SUBJECT: STABILITY ANALYSIS - TAILINGS EMBANKMENT AT MILAN
MILL, HOMESTAKE MINING COMPANY

LICENSING ASSISTANCE/
GEOTECHNICAL AND HYDROLOGICAL
EVALUATIONS/URFO
TASK ORDER NO. 2

REVIEW OF
HOMESTAKE MINING COMPANY
SUBMITTAL
MILAN MILL

APRIL 30, 1987

Figure 1

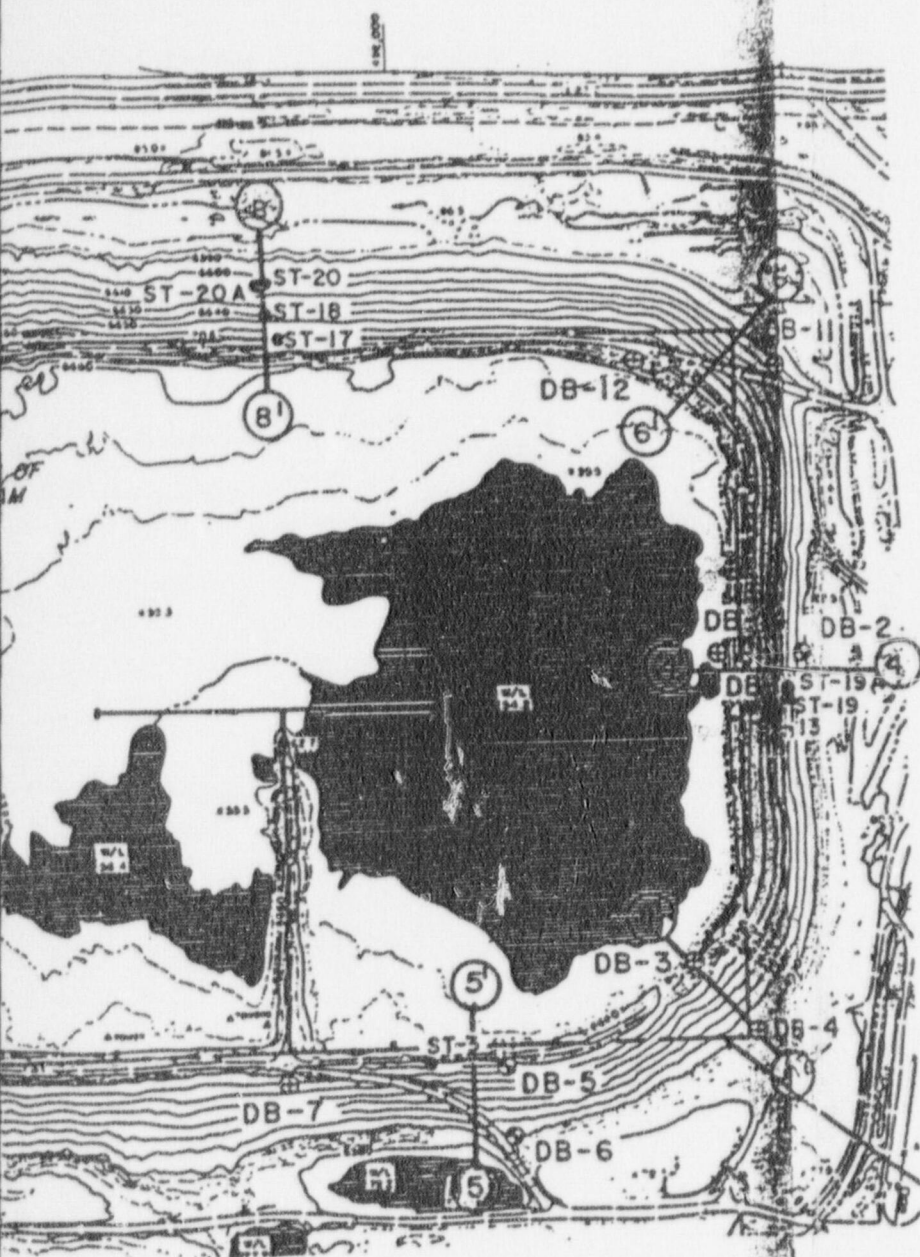
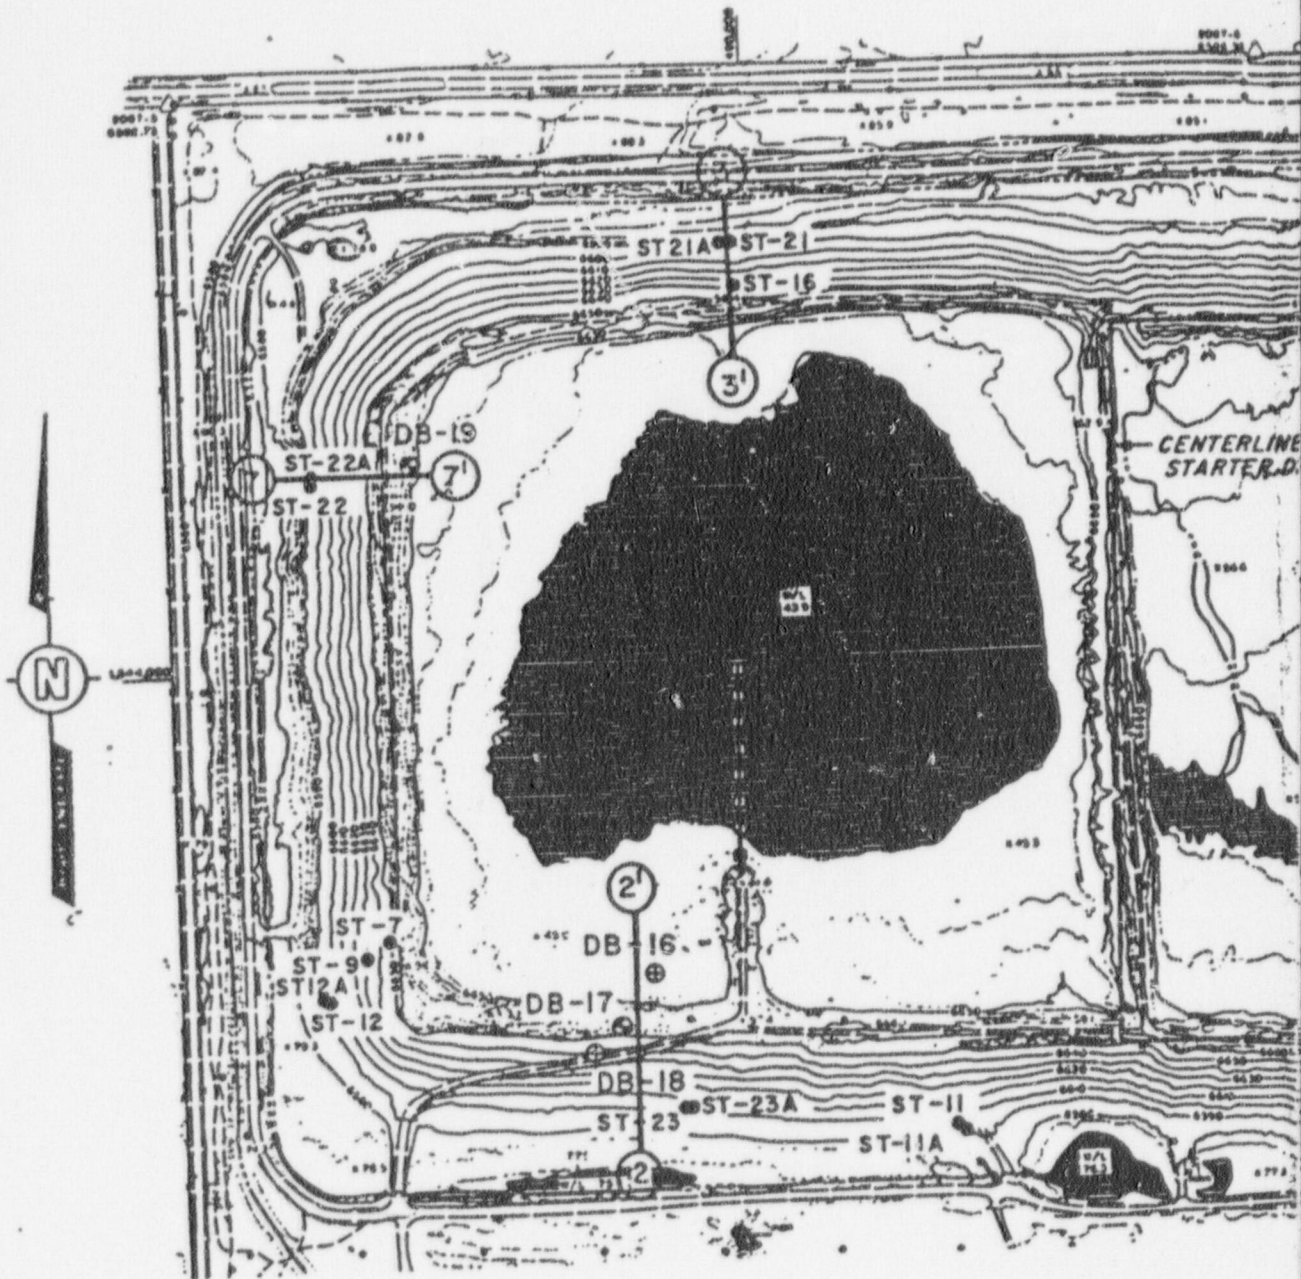
According to surveys dated December 20, 1986, the tailings embankment has a maximum crest elevation of 6680 feet at section 6-6' (Figure 1), a maximum height of approximately 100 feet, and downstream side slopes ranging from 2:1 to 2.3:1. Since operations have been severely curtailed, tailings are presently being deposited in the ponds at a low rate of approximately 2,000 tons per month, according to officials of Homestake Mining Company.

As noted in the D'Appolonia Report, stability analyses were performed on embankment cross sections taken at eight different locations (1-1' through 8-8', shown on Figure 1). Factors of safety at three locations, 1-1', 4-4', and 5-5' (Figure 1) did not meet the requirement of a 1.5 safety factor as specified in the NRC Regulatory Guide 3.11.

The phreatic level used in the stability analyses for the D'Appolonia Report was based upon piezometric measurements obtained in 1980. To monitor the phreatic surface, piezometers were installed in 1977 and in 1980 by D'Appolonia (Figure 1). The D'Appolonia Report noted that the phreatic surface within the tailings embankment did not significantly affect the safety factor until it became 50 percent greater than the piezometric level that existed in 1980. Assessments of the location of the phreatic surface have been made periodically and are kept current by Dr. Kuhn. Based upon the stability results presented in the quarterly stability report dated September 5,

Additional slope stabilization was being performed at the time of the onsite examination in the area of Section 3-3' (Figure 1), which has a relatively low factor of safety as indicated in the table above. The slope stabilization consisted of moving the crest of the embankment towards the pond, resulting in a general flattening of the slope. Based upon the stability analyses performed, this procedure does increase the factor of safety of the slope.

Additional stability analysis, to verify the stability of the tailings embankment, will be required if changes in existing conditions steepen existing slopes, raise the embankment

height, or produce a higher phreatic surface than what was measured for the most recent stability analyses.
